The amendment revises the Technical Specifications to increase Maximum Average Planar Linear Heat Generation Rate (MAPLHGR) operating limits by allowing credit for core spray heat transfer.

PILGRIM NUCLEAR POWER STATION
AMENDMENT TO FACILITY OPERATING LICENSE

Amendment No. 59
License No. DPR-35

SAFETY EVALUATION BY THE OFFICE OF NUCLEAR REACTOR REGULATION

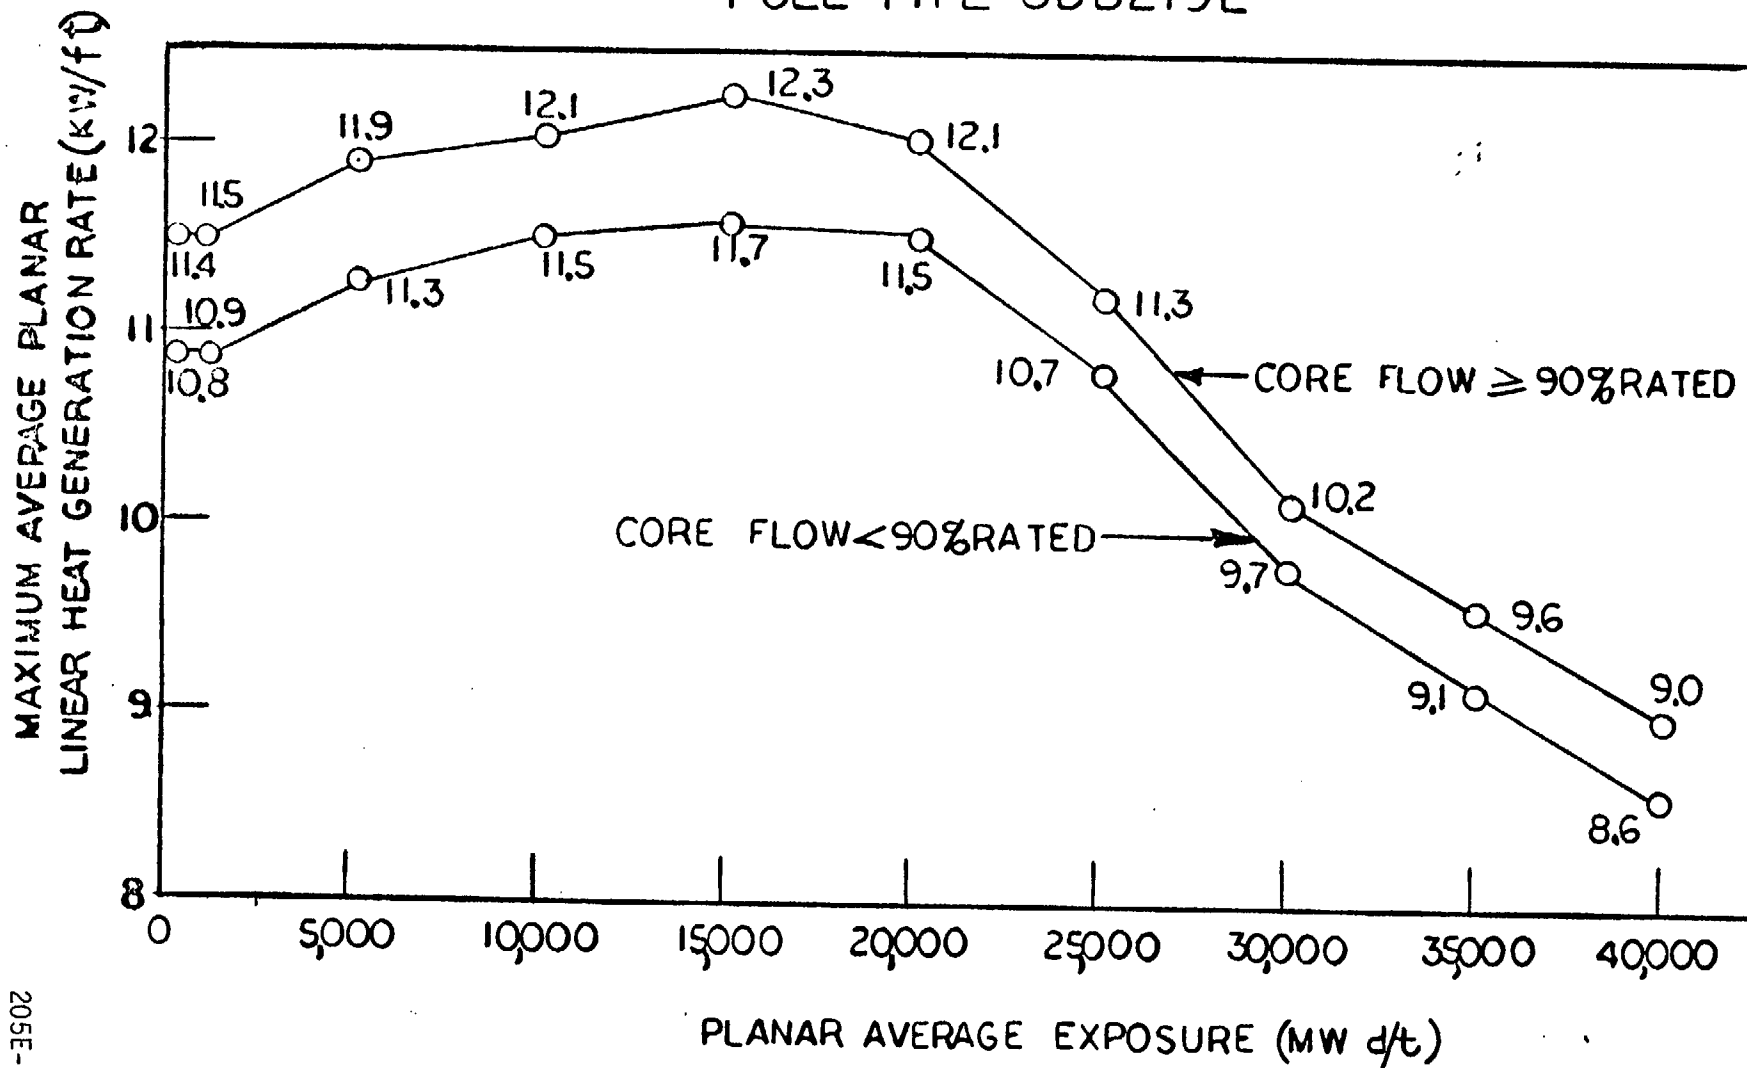
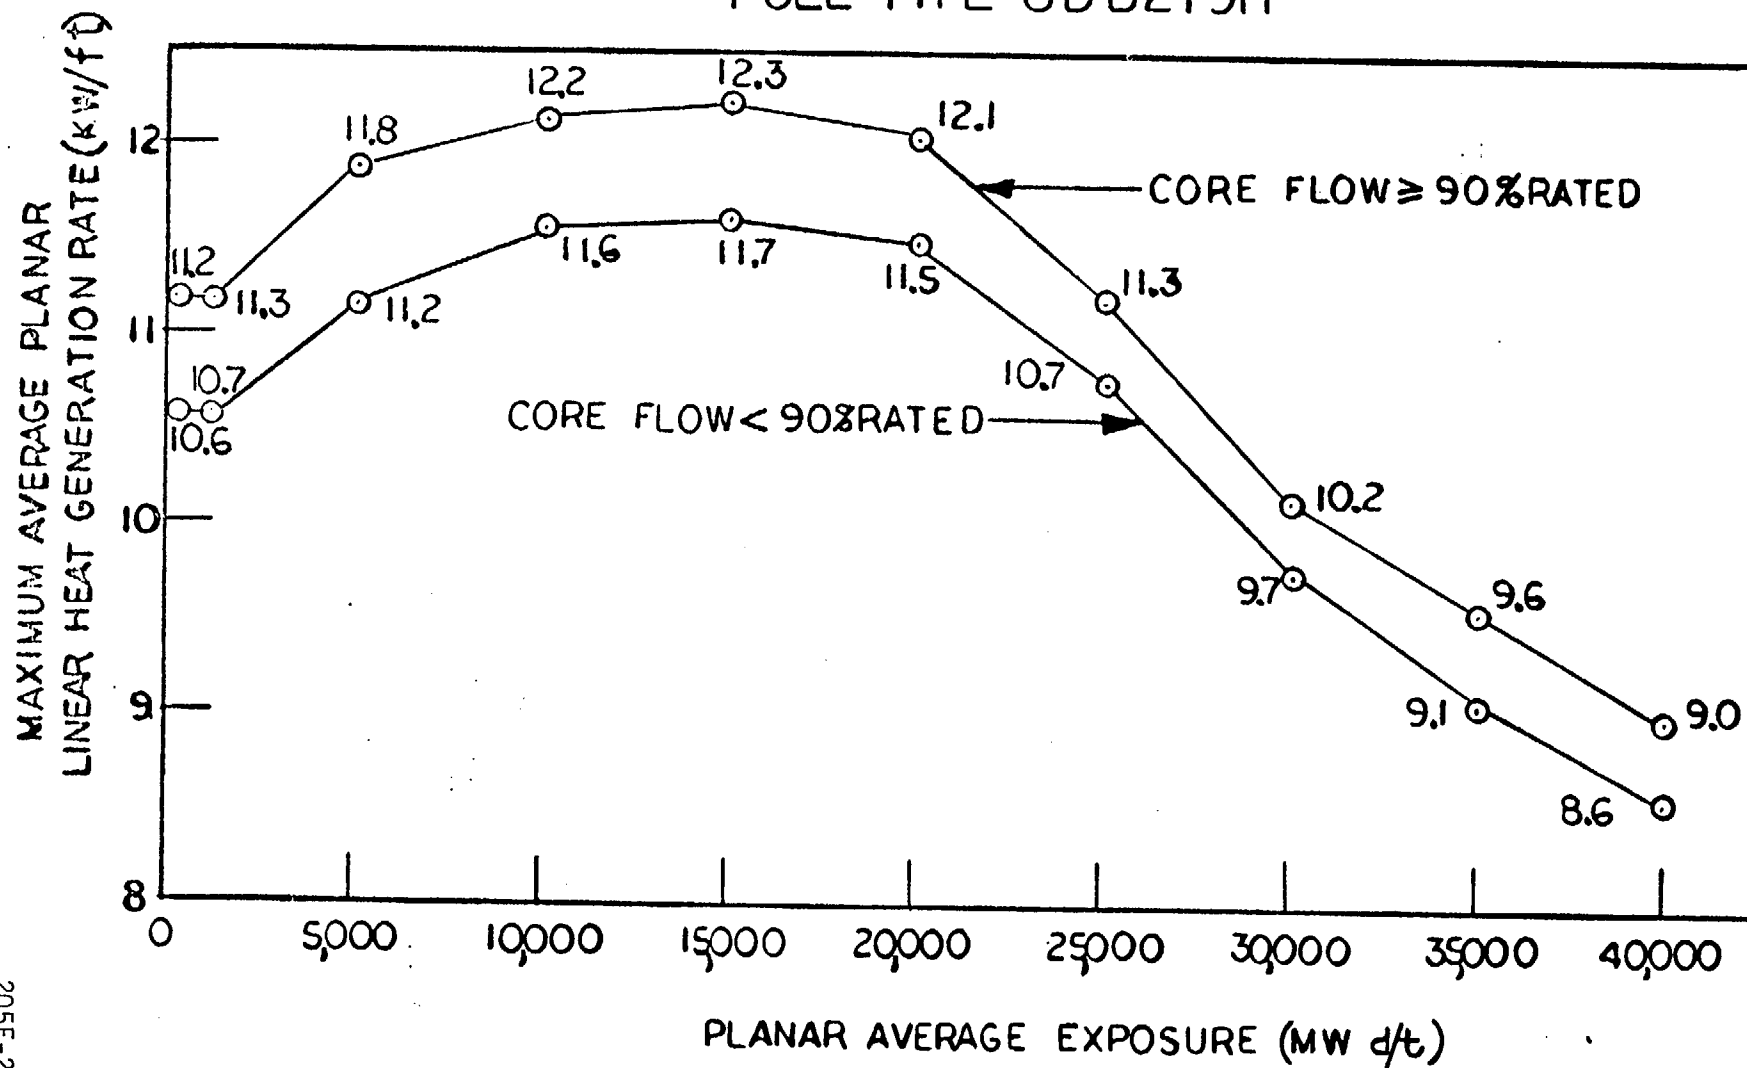
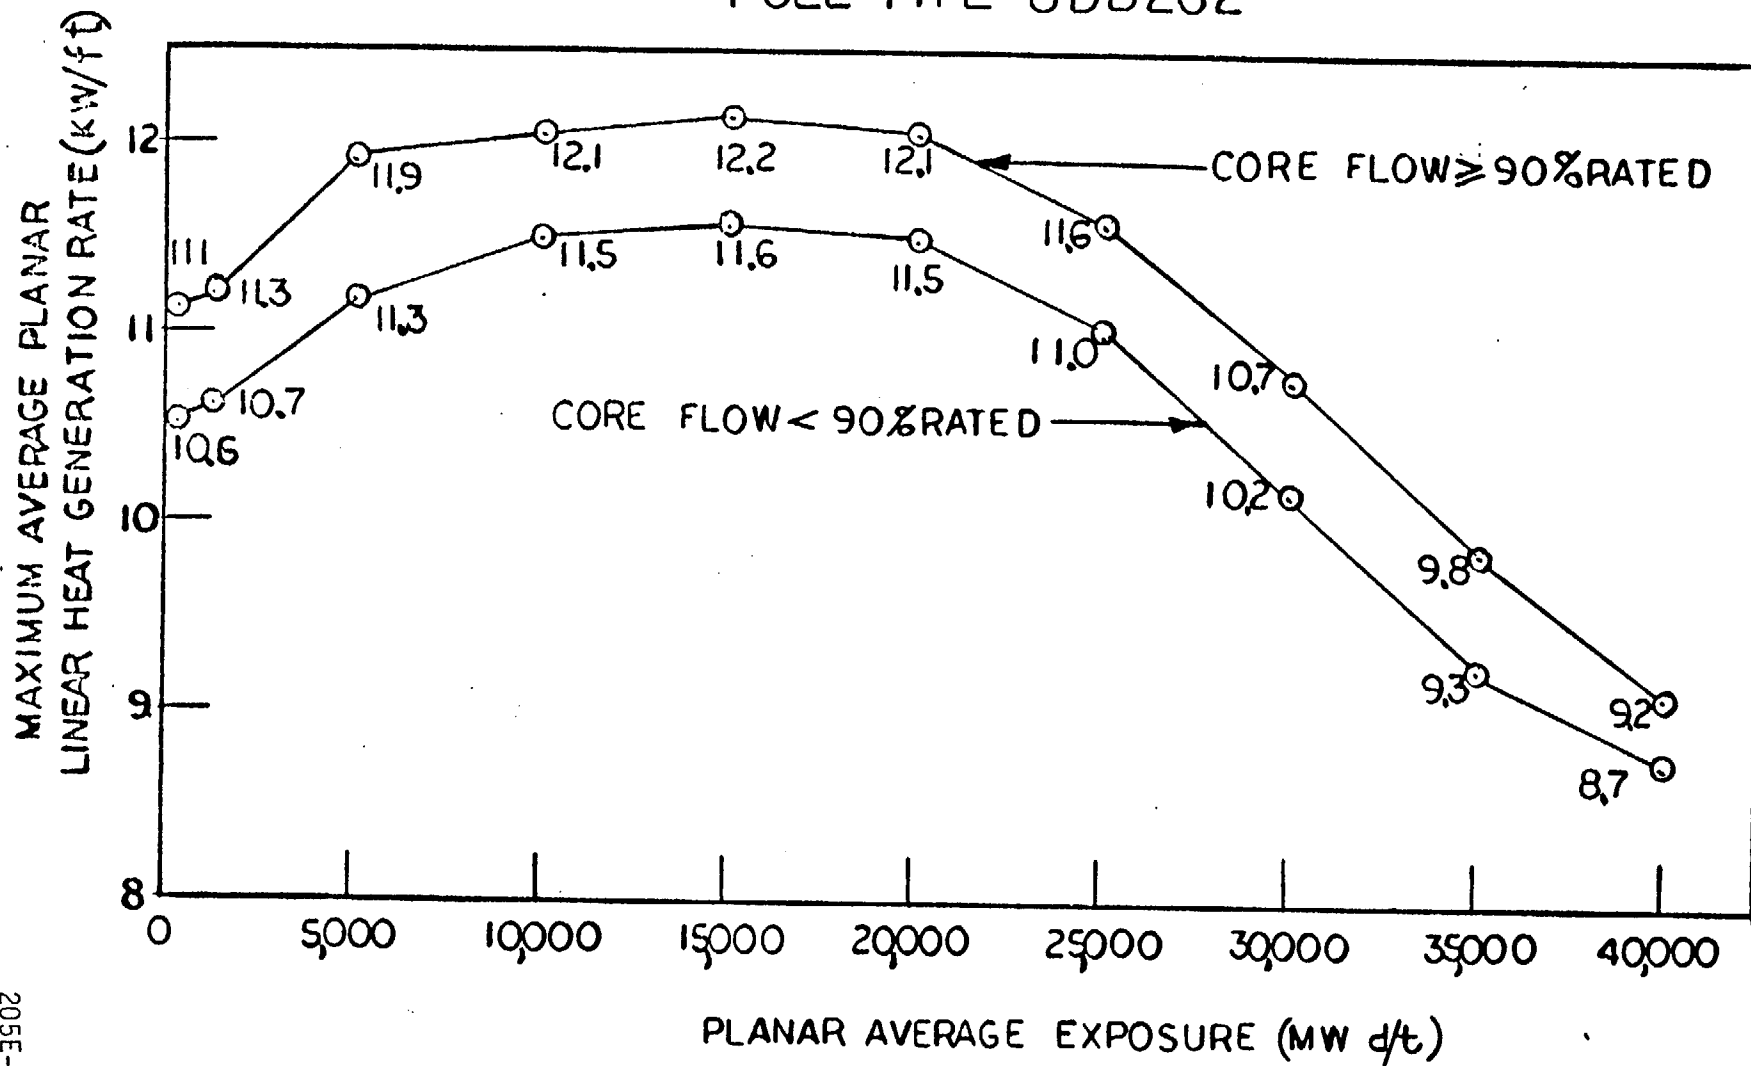
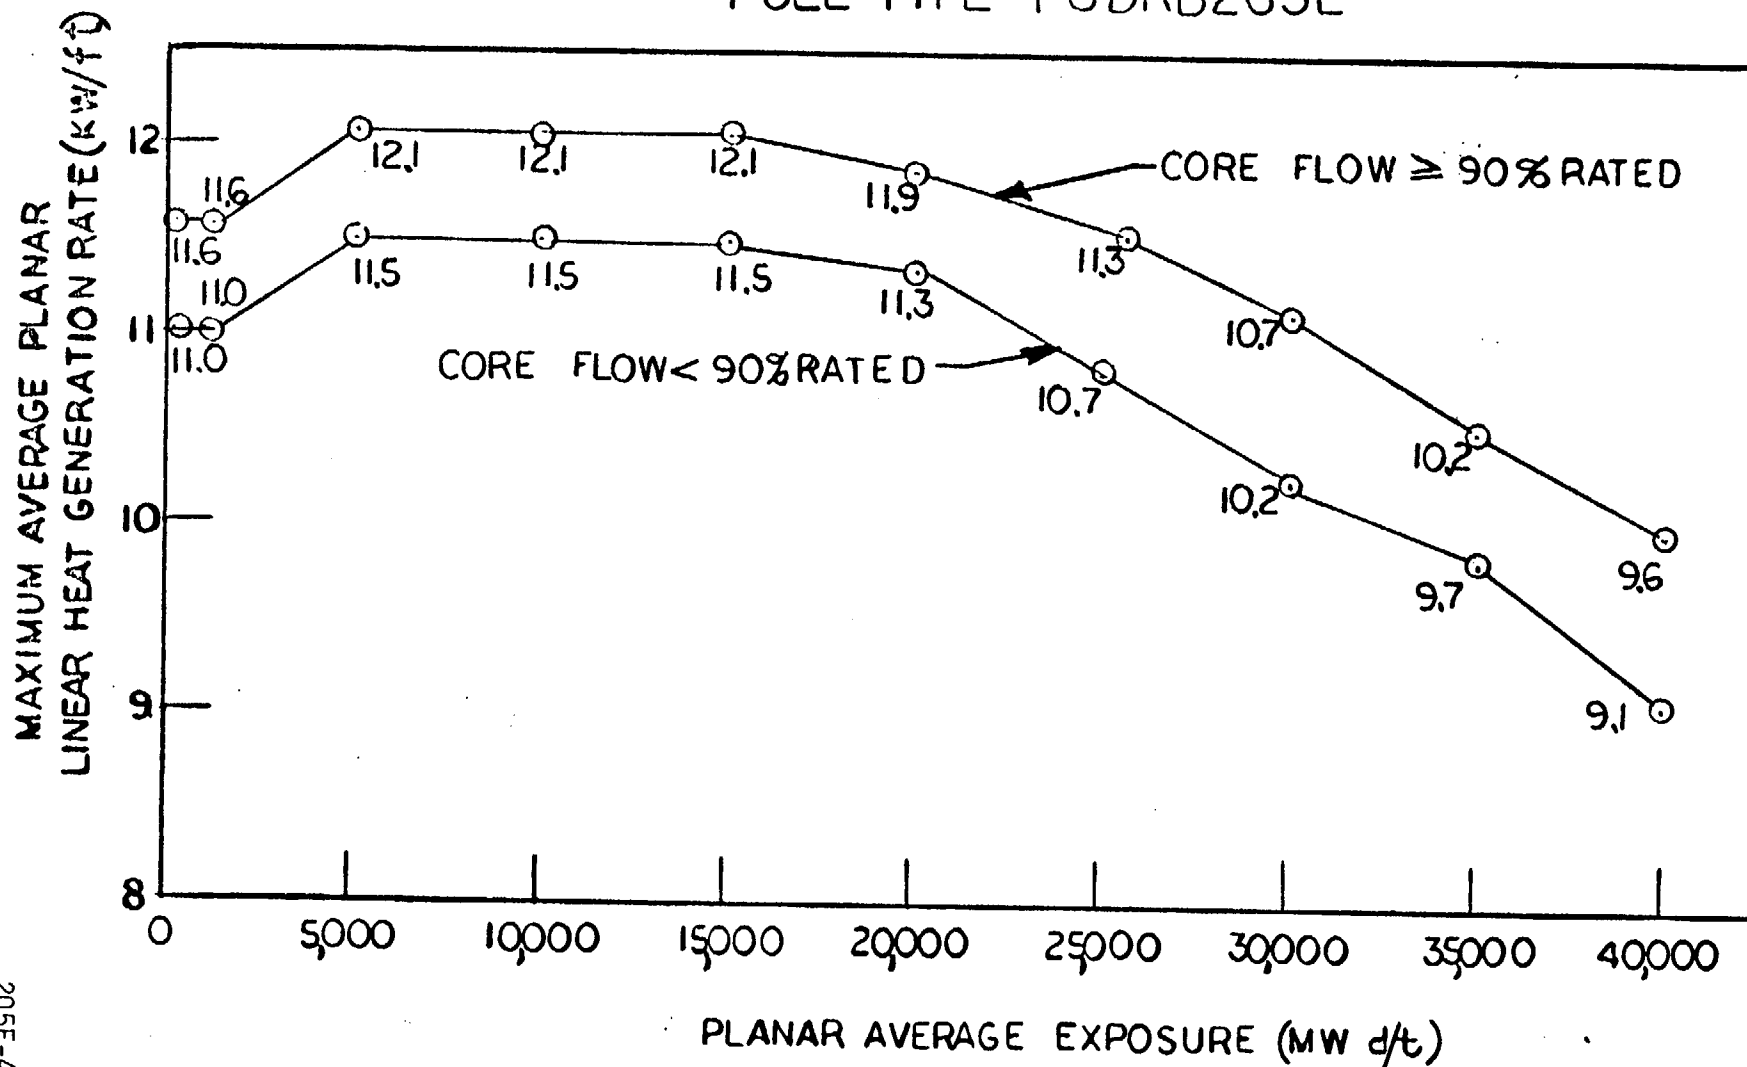
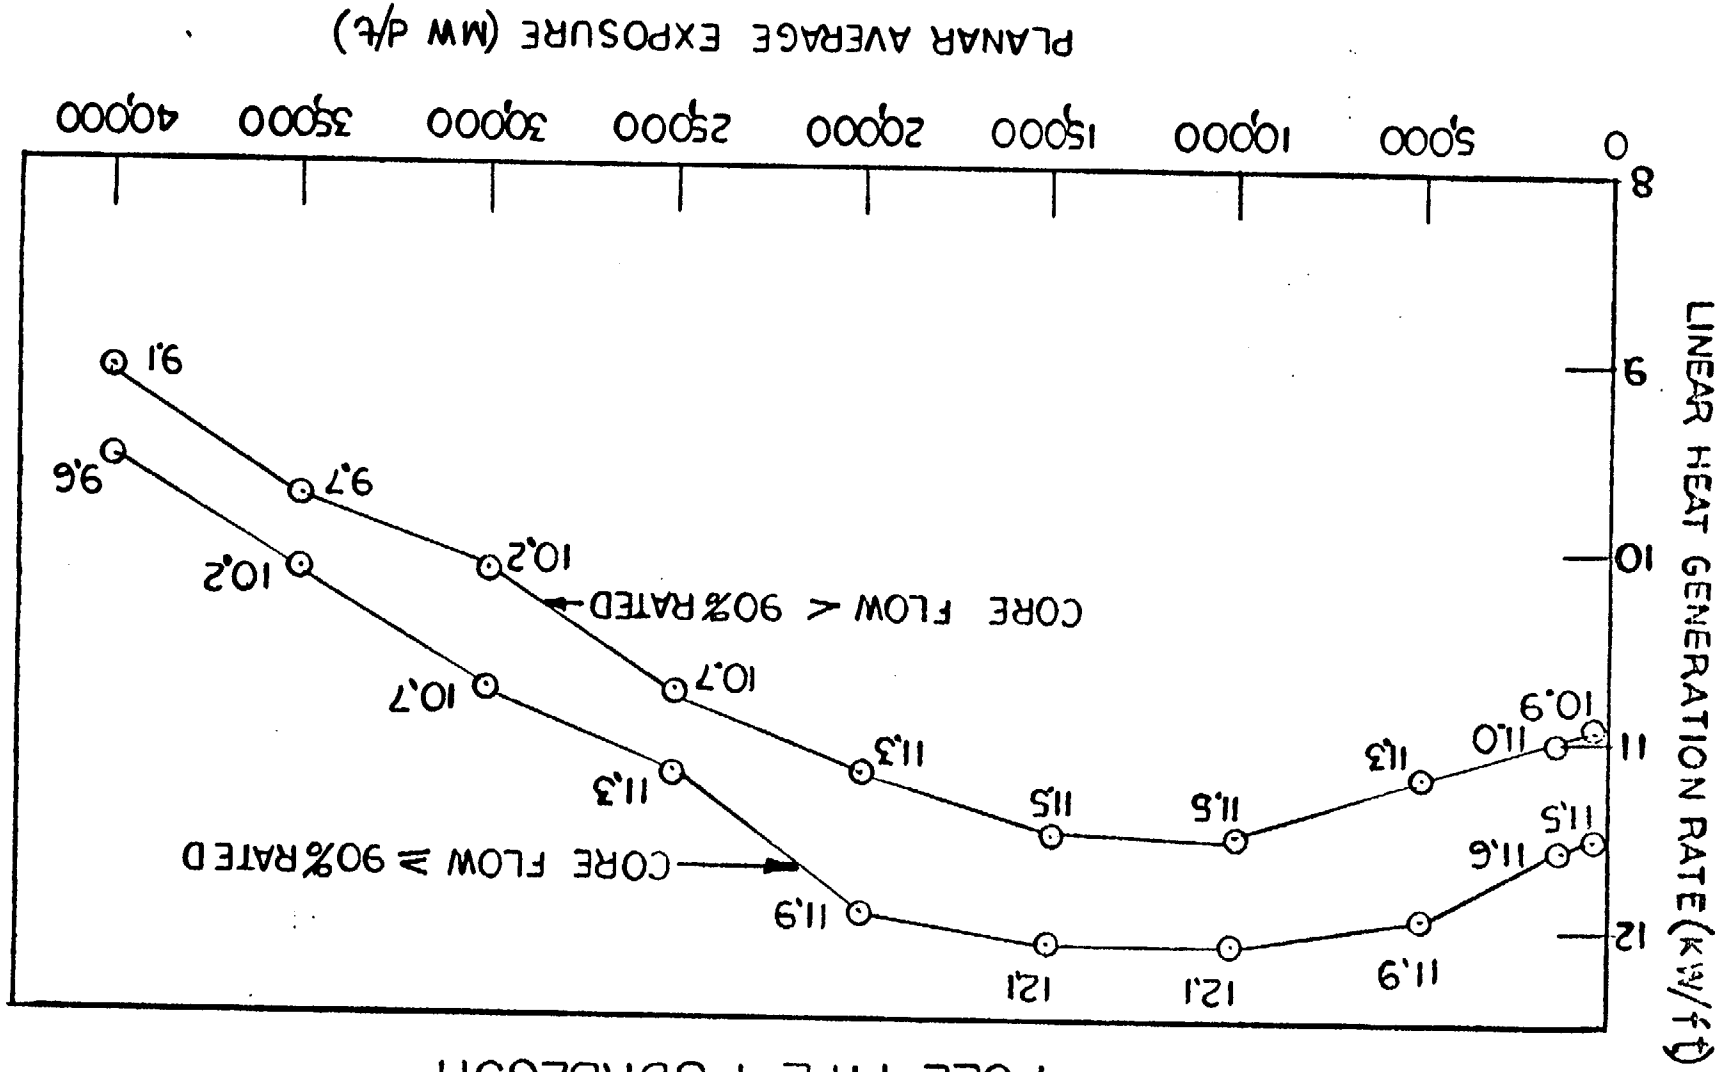
During power operation with both recirculation pumps operating, the APLHGR for each type of fuel as a function of average planar exposure shall not exceed the applicable limiting value shown in Figures 3.11-1 through 3.11-6. The top curves are applicable for core flow greater than or equal to 90% of rated core flow. When core flow is less than 90% of rated core flow, the lower curves shall be limiting. If at any time during operation it is determined by normal surveillance that the limiting value for APLHGR is being exceeded, action shall be initiated within 15 minutes to restore operation to within the prescribed limits. If the APLHGR is not returned to within the prescribed limits within two (2) hours, the reactor shall be brought to the Cold Shutdown condition within 36 hours. Surveillance and corresponding action shall continue until reactor operation is within the prescribed limits.

Based on our review, we conclude that the LOCA calculations submitted for Cycle 6 operation (assuming credit for core spray heat transfer) satisfy the criteria of 10 CFR 50.46 and are therefore acceptable. We have also reviewed the licensee's proposed changes to Technical Specifications involving the increased MAPLHGR operating limits and conclude that these changes are in accordance with these calculations. Consequently, we find them acceptable.
